VILLA ORCHIDS

Details of Additions & Alterations

Villa No	182	Type D ₁	Deluxe / Semi-Deluxe
Buyer Name	A Cast. Vi	neeta Dubey	2 Rahul Soivatav
Phone No.	7889567778	Email (rahul pilot of @gmail.
changes suggester alterations that I deliver all the ma	that I have given the die above referred villa in die by me. I agree to have asked you to me.	the training and the pages attached pay the charges, if take, as per the rate d to be provided by the items to the site by the items the items the items that the items the items that the item	additions and alterations that I herein. Please complete the any, for the additions and a suggested by you. I shall me at the site on or before y the specified date, you may
Buyers sign	Mut	Engg. Sign	
Date:	26/2/18	Date	26/3 /10

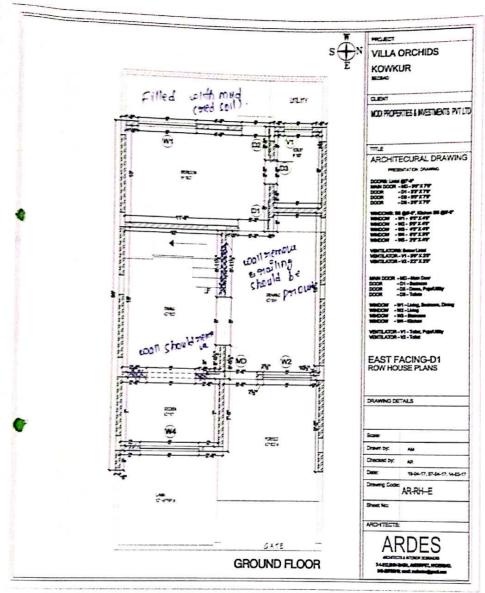
Changes in kitchen platform: (mark on plan)	
Details of solar water heater:	
Setails of solar water heater:	
	-
Other Changes:	
\	
	1 9

Villa 182

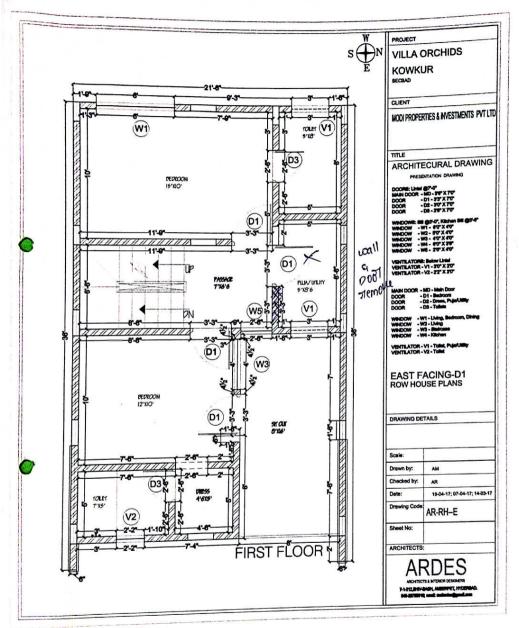
Elazt flood Llazt flood Llazt flood Seword Should be Aleword	Than to so	Godanes:
1) POOTO HILLAY MAIL & DOOD SHOULD BE DOOD SHOULD B		Galory - Plood
1) POOJA WILLAY WALL & DOOM SHOULD A HE SEMANTED TO SE SHOULD BE B DOOM SHOULD B DO MEMOURE A HOUSE B DOOM SHOULD B DO MEMOURE B D D D D D D D D D D D D D D D D D D		wall at kitchen onea should be
1) POOJA WILLAY WALL & DOOM Should	2)	removed & neplace with nalling
a he removed		Flast flood
Changes in flooring:		POOTO HILLY WALL & DOOM Should
	Changes	in flooring:
		-
	-
